# PERMIT

## SEWAGE DISPOSAL SYSTEM

SUBDIVISION Robert A. Mullinix Prop. LOT ROAD 16845 Hardy Road

PLOT PLAN  
 OF LANDS CONVEYED TO  
 ROBERT ALLEN MULLINIX, JR.  
 LIBER 2048 FOLIO 229  
 16815 HARDY ROAD  
 ELECTION DISTRICT N:4  
 HOWARD COUNTY, MARYLAND  
 SCALE: 1"=100' OCT 1990

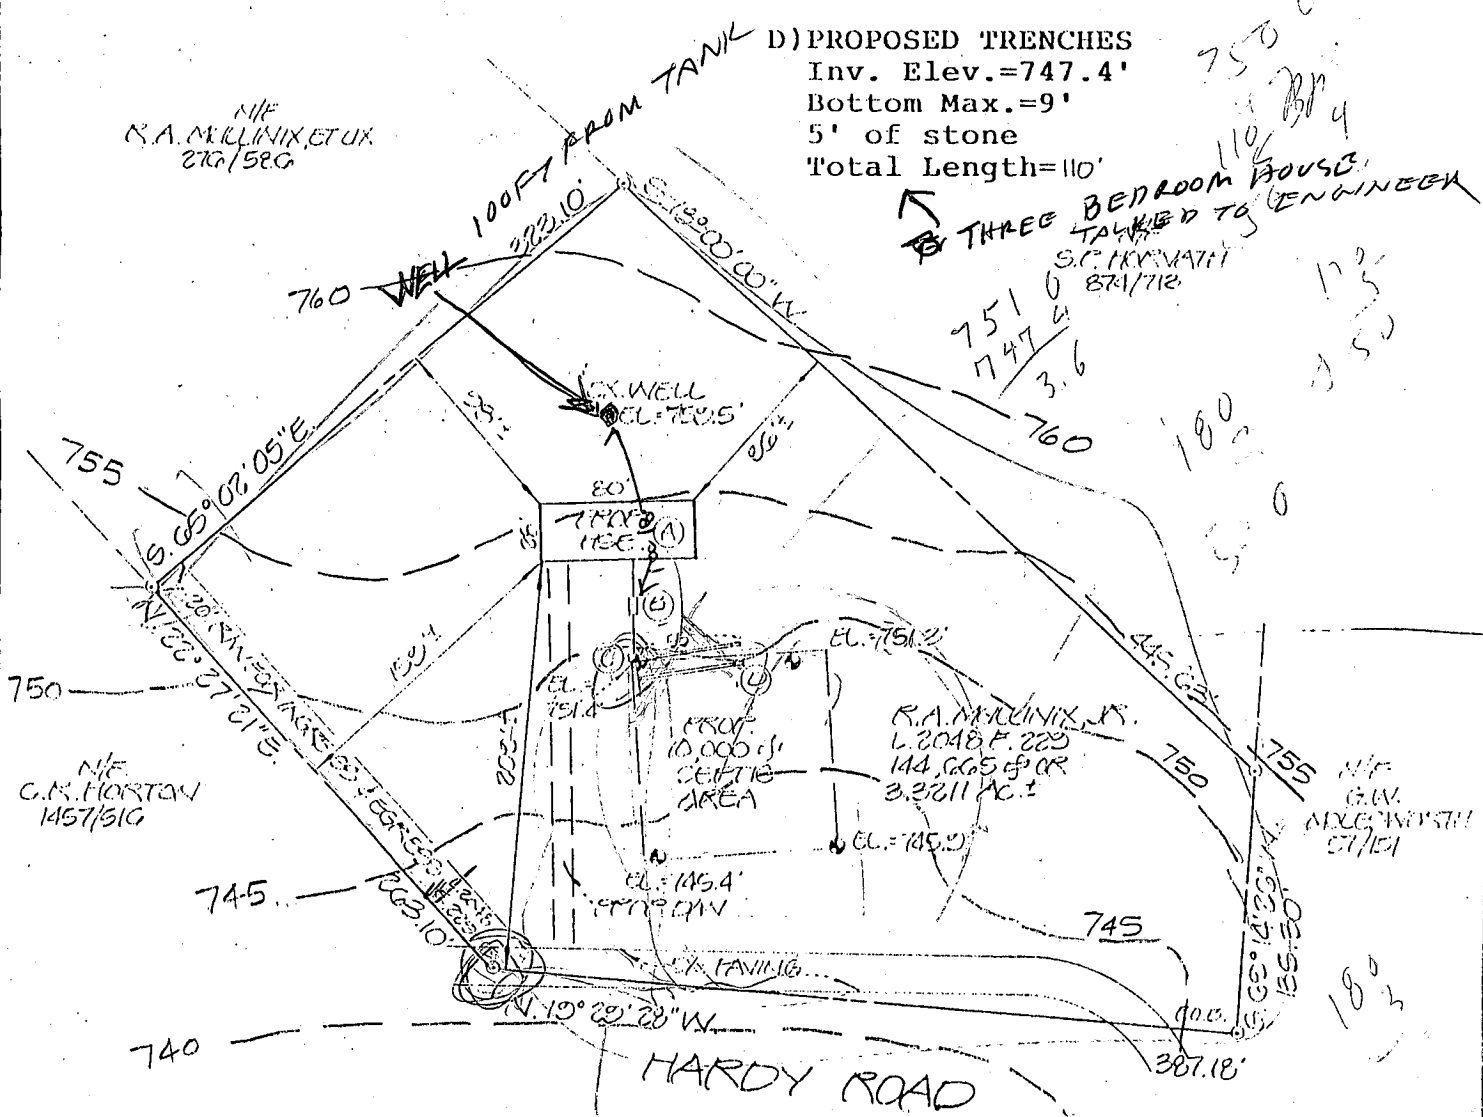
- ① Show Location of Existing Well
- ② Write Exact length of Trencher to be determined at time of septic permit issuance

10/19/90 PLANS OK
